STAFF REPORT

SAUSALITO PLANNING COMMISSION

PROJECT: Akraboff/600A Locust Street
Design Review Permit
DR 08-002

MEETING DATE: June 3, 2009

June 2009 Site Plan

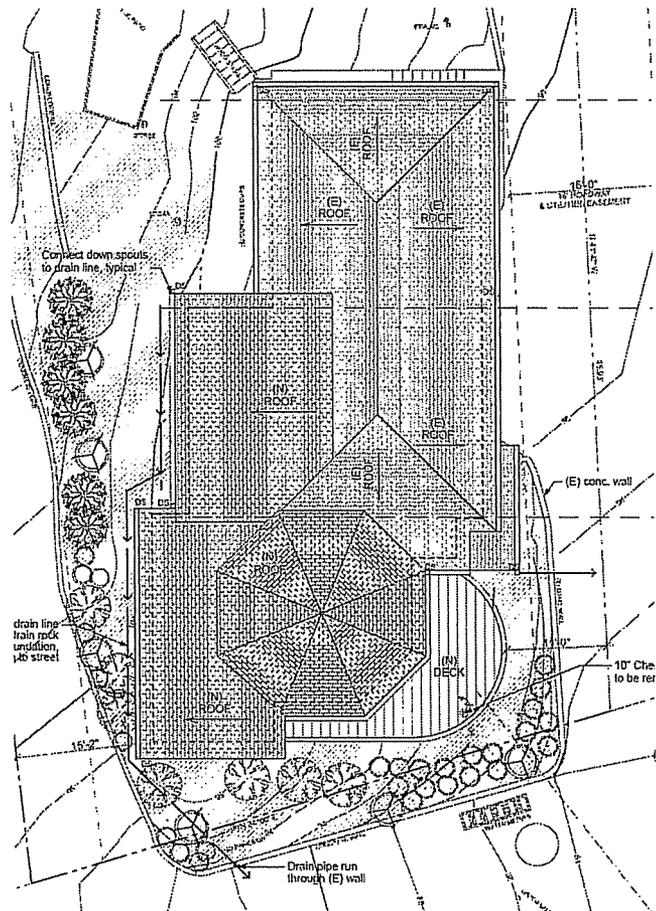
The addition has been redesigned to protect views from 613 Locust (as discussed below in the Analysis section). A major change is the shape of the roof over the living room as the new design features an octagonal roof (see the figures below). As a portion of the previously proposed addition was removed from the eastern corner of the residence, additional square footage has been added to the southwestern side of the home. The previously proposed circular deck remains in the design.

Photograph looking north showing the story poles at 600 Locust

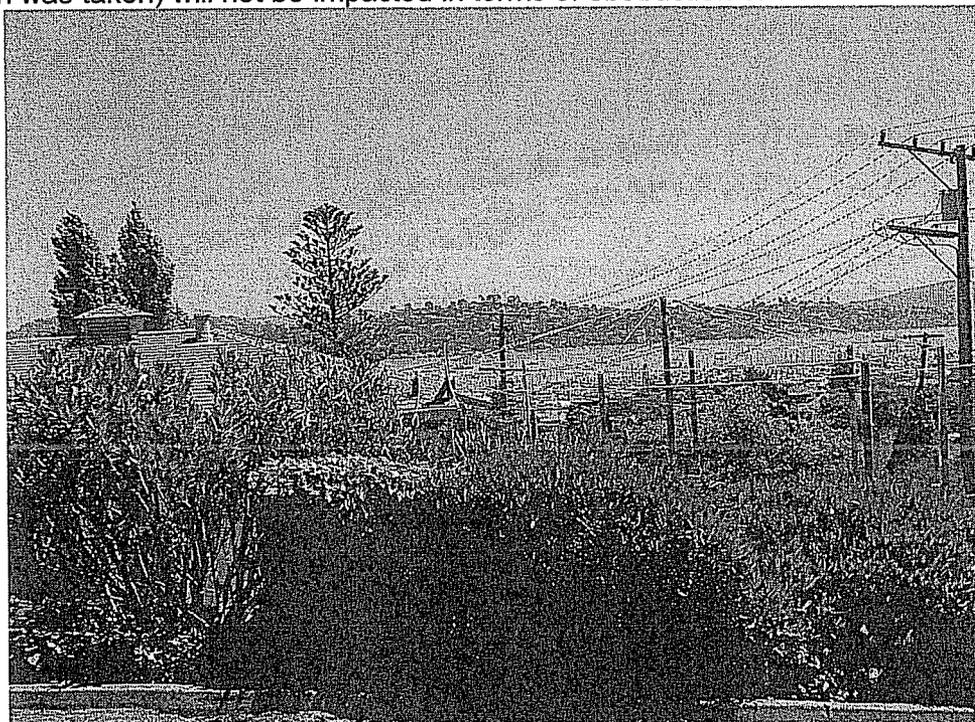
The photograph below shows the proposed massing and rooflines of the addition. The photograph was taken from the private driveway uphill from the project site. Due to the topography in the area, the neighbor at 606 Locust (immediately uphill from where the photograph was taken) will not be impacted in terms of obstruction of views.
